Please accept the following comments from the Pryors Coalition and partners¹ on the November 2020 updated Draft Pryor Mountain TMA Travel Plan and Environmental Assessment. The Pryors Coalition is a collaboration among a number of organizations and many concerned individuals who may or may not be associated with those organizations. The defining characteristic of Pryors Coalition and partners (organizations and individuals) is a strong desire to preserve this very special and vulnerable landscape for the future.

Pryors Coalition et al. comments: 2020 Draft Pryors TMP and EA

Map 1: Red Pryor Trail Area and Demijohn-Penney Peak Area.

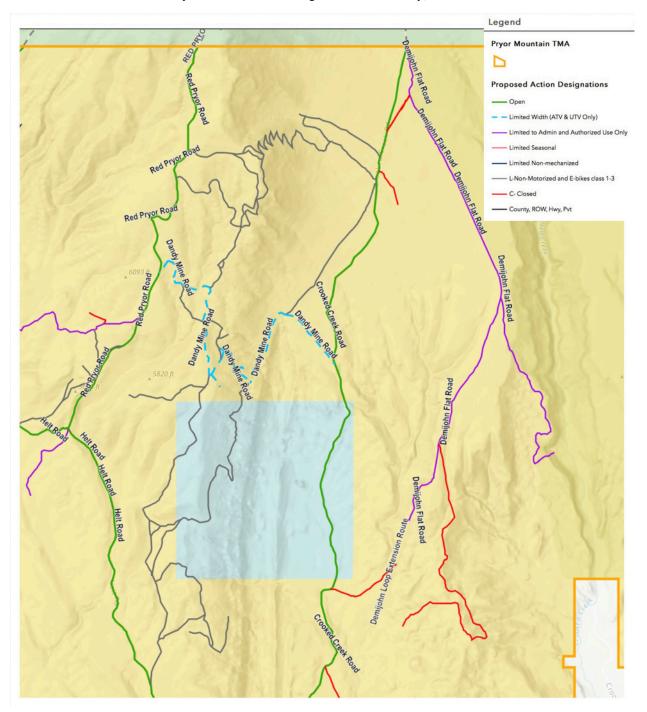
We are very disappointed that the Lisbon-Dandy hiking and equestrian loop hike we had proposed in this area has been coopted by a proposed e-bike and mountain bike play area - much of which is in a designated ACEC. Map 1 shows an exorbitant tangle of redundant routes. A bike play area is not appropriate for the special Pryor Mountain landscape - especially in an ACEC, and when there is an unaddressed need for wheel-free hiking opportunities in the Pryors. There is no need for a bike play area like the Acton Recreation Area near Billings. How is this consistent with the minimization criteria in Executive Order 11644? How does this maze impact natural and cultural resources? How does it minimize conflict between mountain bikes (including motorized e-bikes), and other recreational uses such as hiking and equestrian use? According to the EA there are at least 15 miles of trails in this maze, and more "connections between existing routes" (Appendix E page E-2) may be developed in a future EA. BLM writes that hiking and equestrian use would be allowed, but most of these users would avoid a heavily used bike and e-bike play area.

The EA states that the Lisbon-Dandy mine area "scenery is outstanding and could be complemented with an intentional trail design" (Appendix E page E-2) A 15+ mile biking (including motors) play area will not "complement" the scenery. Designating a 4 or 5 mile non-mechanized Lisbon-Dandy Loop Trail would allow hikers and equestrians to enjoy the outstanding scenery on a route accessible without a 4WD vehicle.

(Detail from BLM's online ArcMap at <u>http://arcg.is/GyPr0</u>. Blue state section indicates scale.) The Red Pryor Trail Area is between Red Pryor Road and Crooked Creek Road. Penney Peak is in the lower right corner of the map, but unmarked.

9. Bent Springs¹⁶ Loop Trail, PM1132, 1134

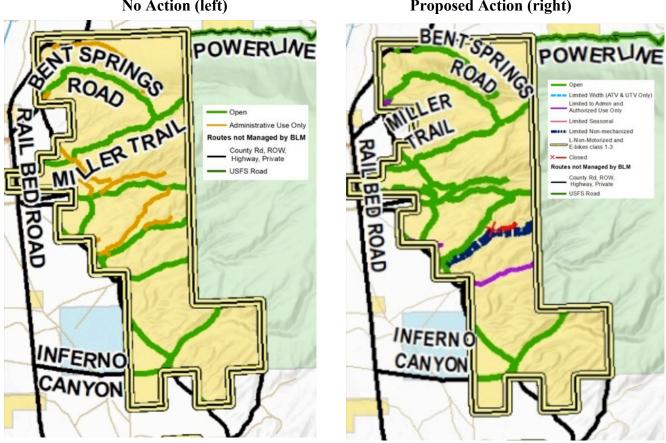
This is an opportunity for BLM to reduce the overwhelming inequity between motorized and non-mechanized recreational opportunities in the Pryors, and reduce conflict among different recreational uses. Importantly this is an opportunity that does not depend on collaboration with the USFS since it is entirely on BLM land. It is an opportunity to create an excellent hiking loop free from the commotion of wheeled vehicles. The route would be easily accessible for hikers without 4WD.

BLM's rationale for rejecting our request for designation of this non-mechanized loop is tone-deaf.

Motorized users have 134 miles of "different experiences" including "traversing them along" edges of the Pryors like Sykes Ridge. Wheel-free users have only 11 miles of experiences in the Proposed Action. Hikers also appreciate "different experiences" and the "view of Pryor Gap and Sage Creek." It is an easy, level walk from Miller Trail (a quarter mile or less) for ATV riders to see this view.

We again request that BLM convert the redundant Bent Springs Road, PM1132, to non-mechanized use only, and designate the unneeded administrative route to the north, PM 1134, for non-mechanized use only. Bent Springs Trail is not needed to provide access to Miller Trail continuing onto USFS land. These two routes combine to make much needed loop hike, but do not connect for wheeled vehicles. BLM provides no rationale for opening dead-end 1.7 mile PM 1134 to public motorized use.

F. Rerouting of Stockman Trail, PM1143

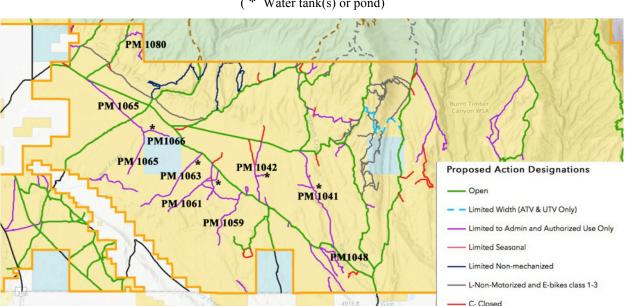
Avoiding building 1.7 miles of new road would be best for the Pryors which are already abused by too many miles of roads. We urge BLM to legally assert the public's right to the existing access by prescriptive easement. This route has been on USGS topo maps for decades as "Bent Trail," and is shown on a 1980 USFS Travel Plan map.
